GreenStar™ Software Update 2016-2

Release Notes

Application Controller 1100: iGrade™, John Deere Active Implement Guidance

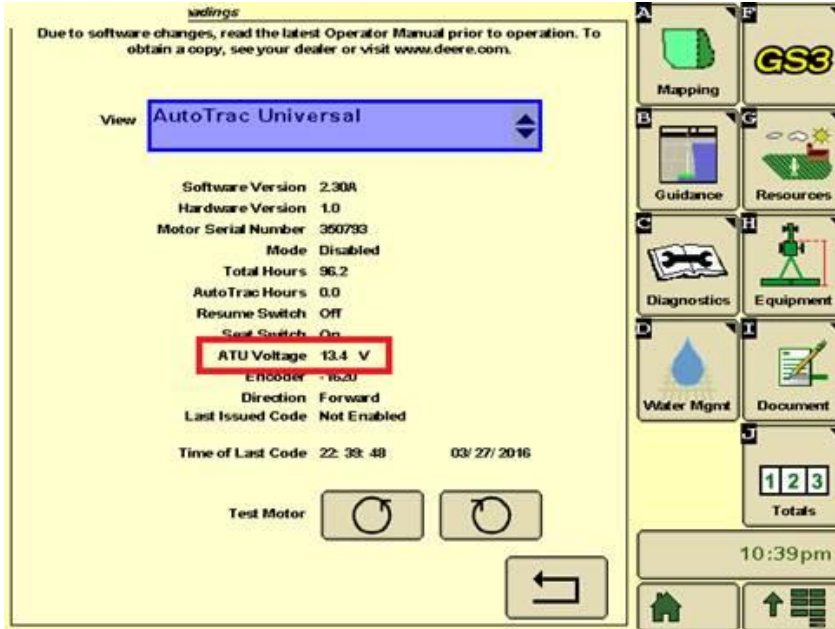
Application Controller 1100 – Is now compatible with StarFire™ 6000 Receiver

AutoTrac™ Universal (ATU) 200

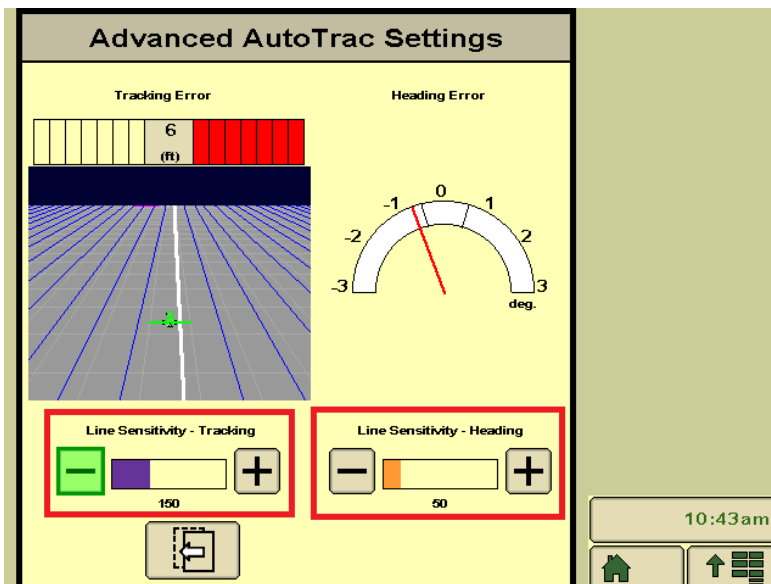
ATU Voltage – Is now available in the ATU Diagnostics page.

Line Sensitivity – Tracking and Line Sensitivity – Heading adjustments will be able to be made in the activity monitor page.
